DATE: November 2, 2016

TO: Design Review Commission
FROM: Sean K. Gallegos, Assistant Planner
SUBJECT: 16-SC-41 – 1832 Fallen Leaf Lane

Approve design review application 16-SC-41 subject to the listed findings and conditions

This is a design review application for a new two-story house. The project includes 2,255 square feet on the first story and 1,029 square feet on the second story. The following table summarizes the project's technical details:

RESIDENTIAL DESIGN REVIEW PACKAGE FOR KASARABADA RESIDENCE

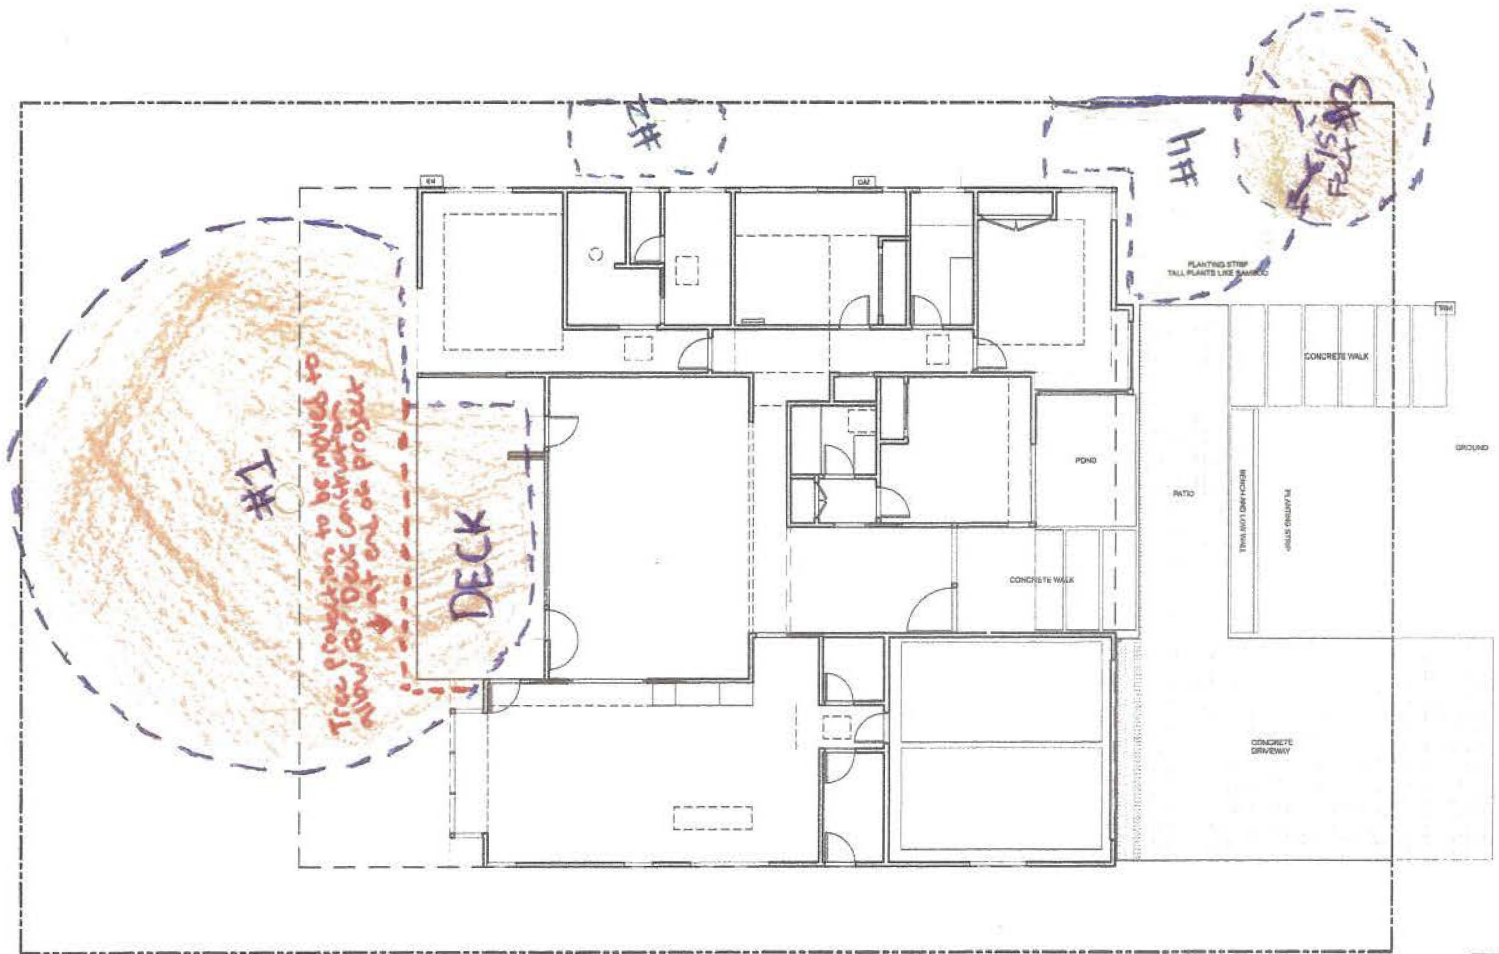
As requested on Monday, August 29, 2016, I reviewed latest site plan A.1 dated 8/29/16 for the above site. This review is required by the city of Los Altos as a condition of approval.

The new plans are far less closer to the tree than the previously reviewed plans. Impacts will be lower than expected. Tree protection fencing shall be placed as close as possible to the proposed work while still allowing for construction to safely continue. Any excavation underneath this tree's dripline will need to be done by hand in order to expose roots in the area of work. Any roots over 2 inches in diameter to be cut must first be inspected by the site arborist. I have reviewed all of the plans for this project. The project is designed in accordance with my recommendations. Tree protection measures have been well displayed in the plans. Impacts to the tree is expected to be minor with no long term impacts.

Showing coast live oak tree #1

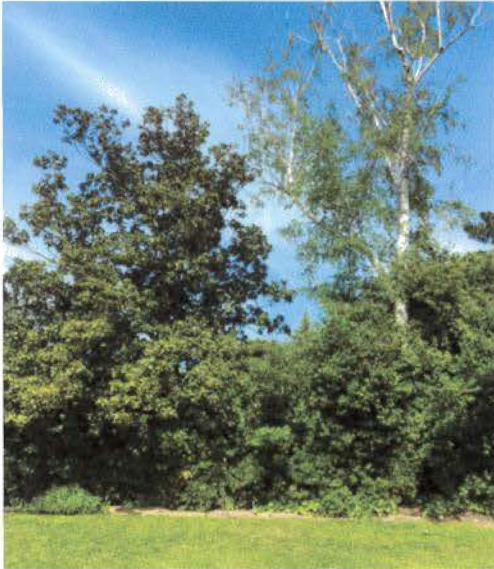
Coast live oak tree #1 is the only native tree on site. This tree is located in the center of the backyard and provides the home with screening and shade. The tree has been well maintained as it has been recently pruned to lighten the heavy lateral limbs and to allow for proper air flow throughout the canopy. This tree is a protected tree in the city of Los Altos as the diameter is 34.8 inches. The existing home is 19 feet 5 inches from the tree. The corner of the proposed home foundation will encroach out an extra 4 feet 8 inches towards the tree from the location of the existing home. This section of the proposed home is on the north side of the property and will be a corner cut out of the trees drip line. Corner cuts have less impact to trees as the percentage of roots affected is significantly lowered as opposed to the whole home being moved towards the tree. The remaining foot print of the proposed home will be near the same as the existing home.

When excavating for the corner of the home beneath the trees dripline, hand tools should be used in order to excavate to the required depth of the proposed foundation. During the hand excavation, if roots are found over 2 inches in diameter they shall be exposed and remain intact for the site arborist to inspect. At the time of inspection the site arborist will document the work being done and will properly cut roots that need to be cut. Hand excavation and exposing roots is better than using heavy equipment to dig as roots would likely splinter further back towards the tree than necessary. Also heavy equipment will compact the soil underneath the trees dripline. As part of the mitigation measures for this tree an irrigation schedule may need to be set up to assure the exposed roots to not dry out and die further back towards the tree. Roots to be cut over 2 inches in diameter must be done by the site arborist. After roots are cut the face of the foundation shall be covered in burlap and kept moist so that roots do not dry out. Impacts from this proposed work are expected to be minor.

A deck is also proposed near coast live oak tree #1. The proposed deck will extend out from around the same area as the existing home towards the tree. The proposed deck will be 10 feet 3 inches away from the tree. It is recommended the deck be elevated and supported by footings. Footings shall be hand dug and be able to be moved to a different location if roots over 2 inches in diameter are found. This will significantly lower impacts to the trees health. The deck shall be built at the end of the project so that the tree can have the maximum amount of tree protection fencing throughout the entire project. This will decrease the chance of compaction to the soil around the tree. Anytime the tree protection fencing is to be moved the site arborist shall inspect the fencing to ensure the tree is being adequately protected.
